Office Action Summary

10/772,782

STREETER ET AL.

DETAILED ACTION

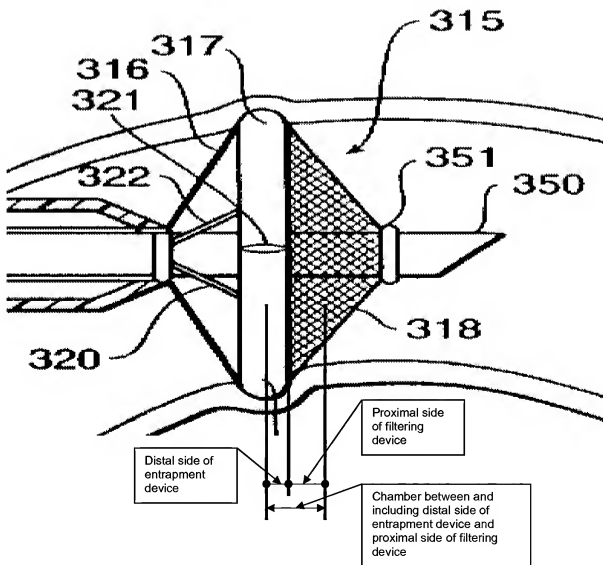
2. Claims 1-10, 14-15, and 16-20 are rejected under 35 U.S.C. 102(b) as being anticipated by BARBUT et al (5,769,816).

As to claim 1, BARBUT (Figs. 6-7 and reproduced partial Fig. 7 above) discloses a filter device having a first given perimeter defined by rib (351), entrapment device (seal 317, spokes 316) having a selective opening defined by a perimeter of seal (317) to define a second given perimeter. The selective opening has at least one spoke (316) as a restriction element, which prevent or hinder a back flow of debris. The distal side of entrapment device and the proximal side of the filter define a chamber for entrapping debris from the vascular system of a patient.

As to claim 2, BARBUT (Figs 6) discloses cannula (350).

As to claim 3, BARBUT (Figs. 6-7) discloses deployable frame (380, 383).

As to claims 4-5, BARBUT (Figs. 6-7) discloses compliant outer cuff or seal (317) surrounds deployable frame (380, 383).

As to claim 6, BARBUT (Figs. 6-7) discloses radially inflatable cuff or seal (317).

As to claim 7, BARBUT (Figs. 6-7) discloses filter device comprising filter bag (318).
